MEMORANDUM TO: Joseph A. Murphy, Chairman
Committee To Review Generic Requirements

FROM: Jon R. Johnson, Deputy Director **/RA/**
Office of Nuclear Reactor Regulation

SUBJECT: REQUEST FOR REVIEW AND ENDORSEMENT OF THE PROPOSED
BULLETIN TITLED "CIRCUMFERENTIAL CRACKING OF REACTOR
PRESSURE VESSEL HEAD PENETRATION NOZZLES"

Figure of Typical CRDM Nozzle Penetration

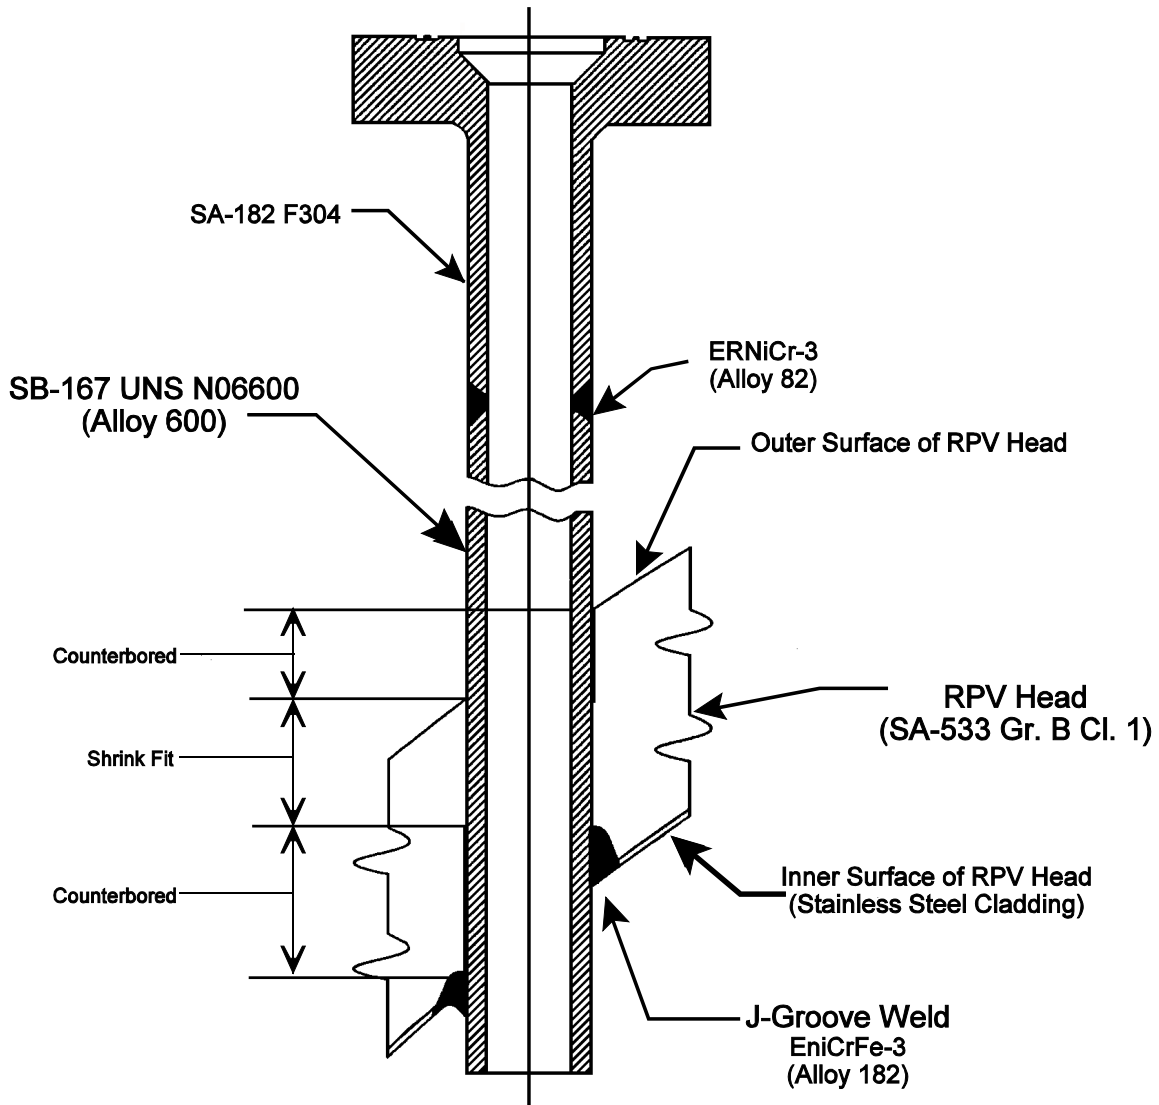
The CRDM nozzles at ONS3 are approximately ~~5-feet~~ 5 feet long and are J-groove welded to the inner radius of the RPV head, with the lower end of each nozzle extending about ~~6-inches~~ 6 inches below the inside of the RPV head (see ~~Figure 1~~ Attachment). The nozzles are constructed from 4-inch OD Alloy 600 Inconel procured in accordance with the requirements of Specification SB-167; to the 1965 Edition, including Addenda through ~~the~~ Summer 1967 Addenda, of Section II of the American Society of Mechanical Engineers (ASME) Boiler and Pressure Vessel Code. The weld preparation for the installation of each nozzle in the RPV head was accomplished by machining and buttering the J-groove with Alloy 182 weld metal. The RPV head was subsequently stress relieved and then the final machining of the CRDM penetrations, including ~~the~~ counterbore, was
